SAS SUPERSTRUCTURE - CONDUIT PLAN

CONTRACT CHANGE ORDER NO. 42
 SHEET ____ OF ____

SAS SUPERSTRUCTURE ROADWAY EASTBOUND LIGHTING AND ELECTRICAL SYSTEMS

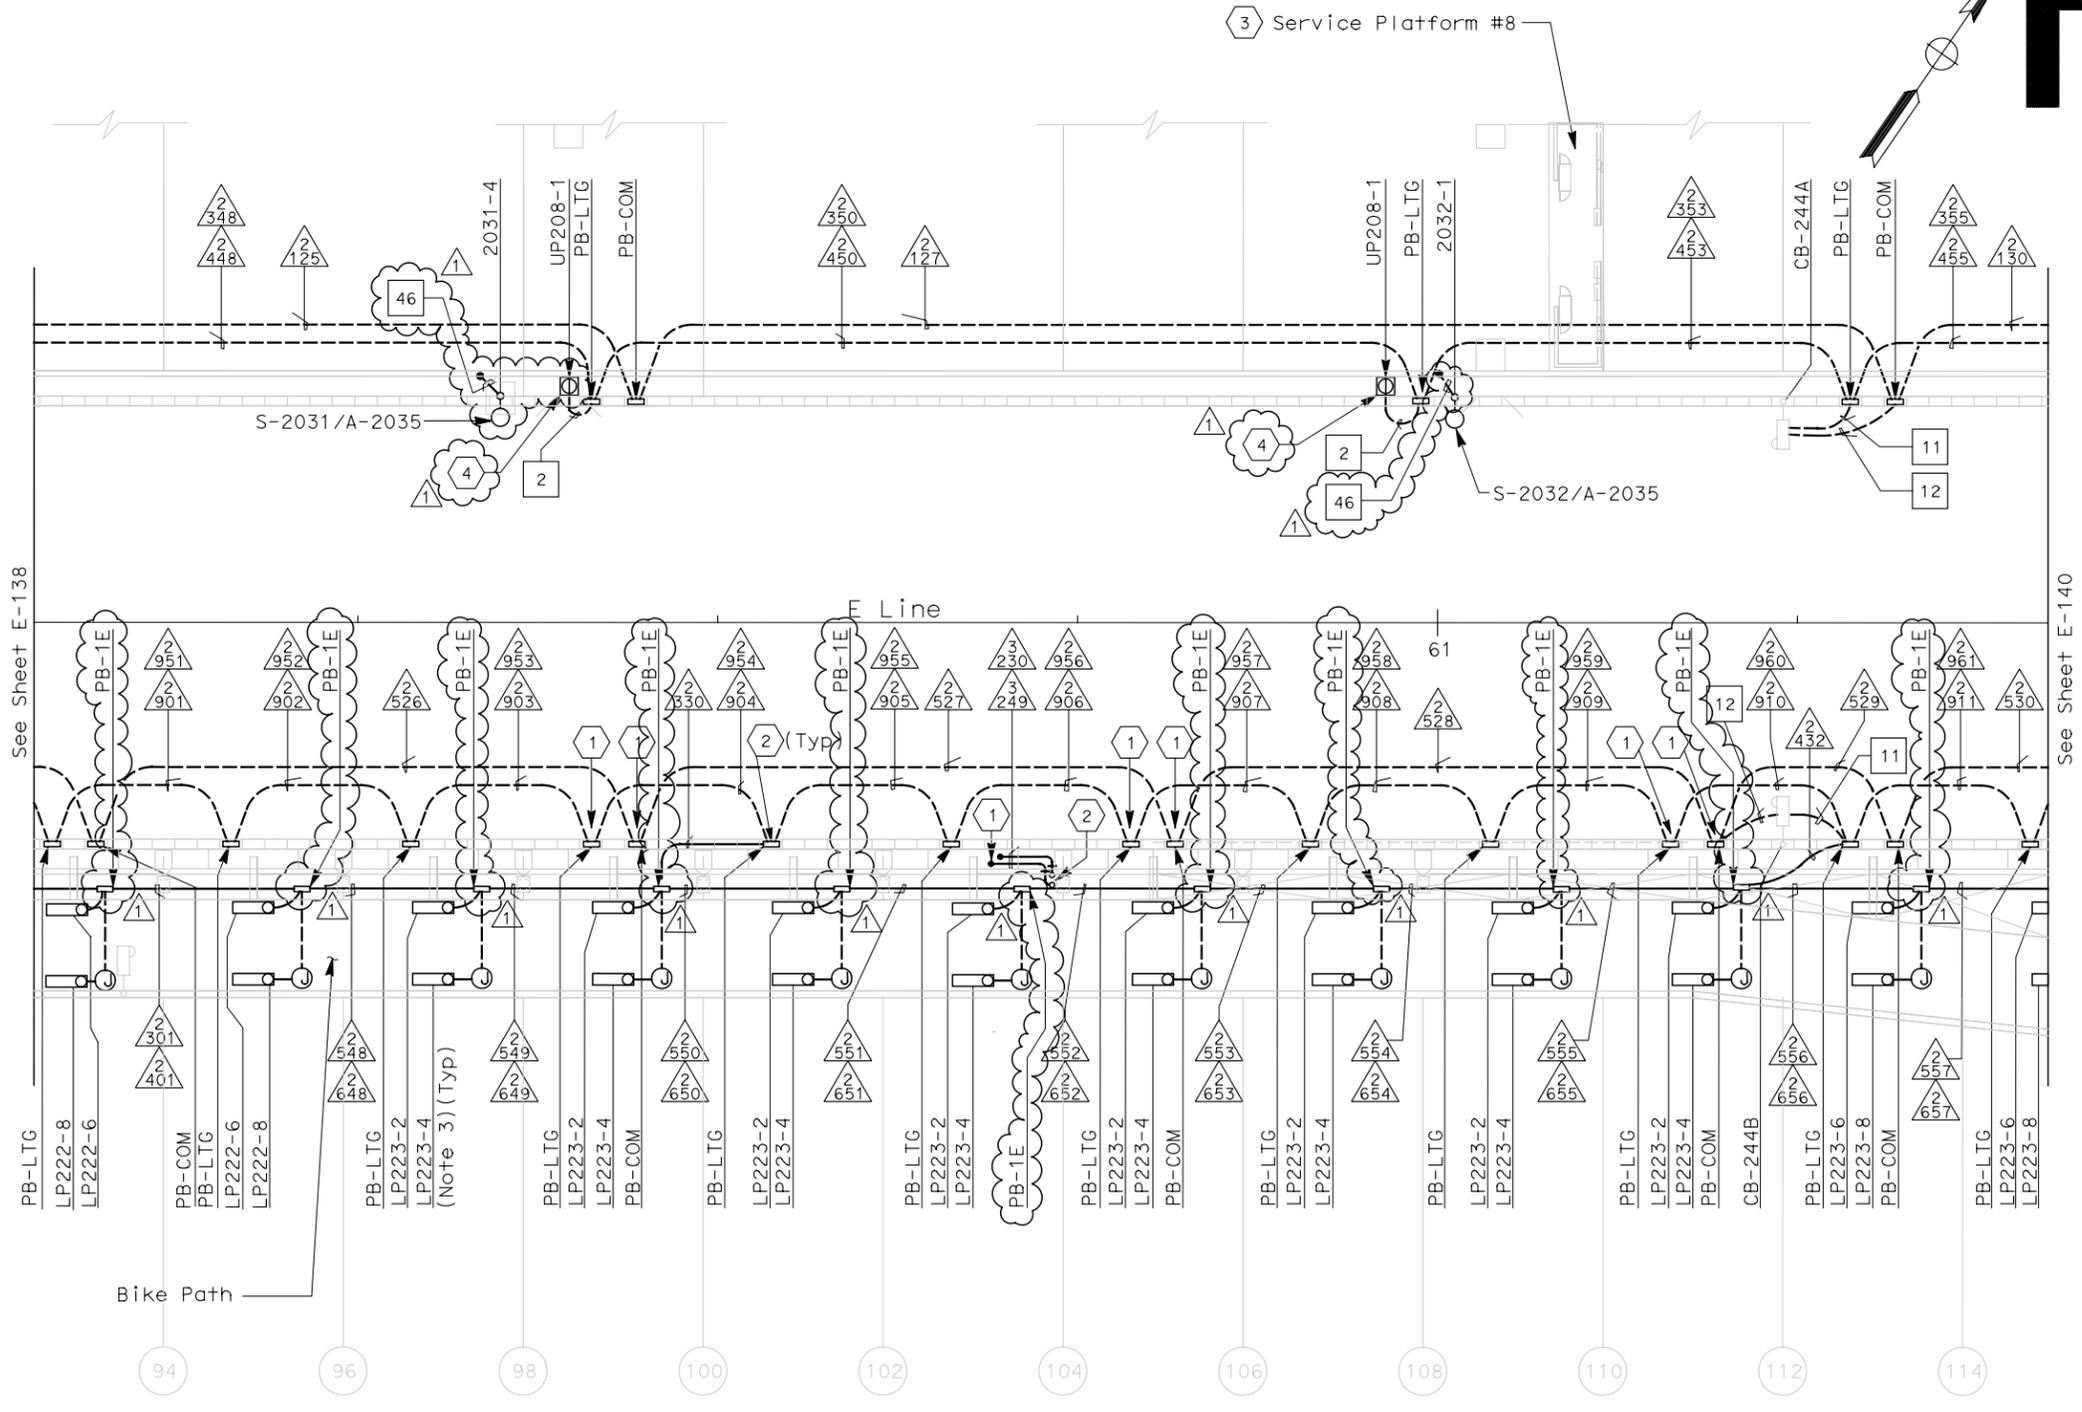
MARK	DATE	DESCRIPTIONS	BY	CK	CCO
△	8-06-07	Electrical modifications.	MP	RR	42
REVISIONS
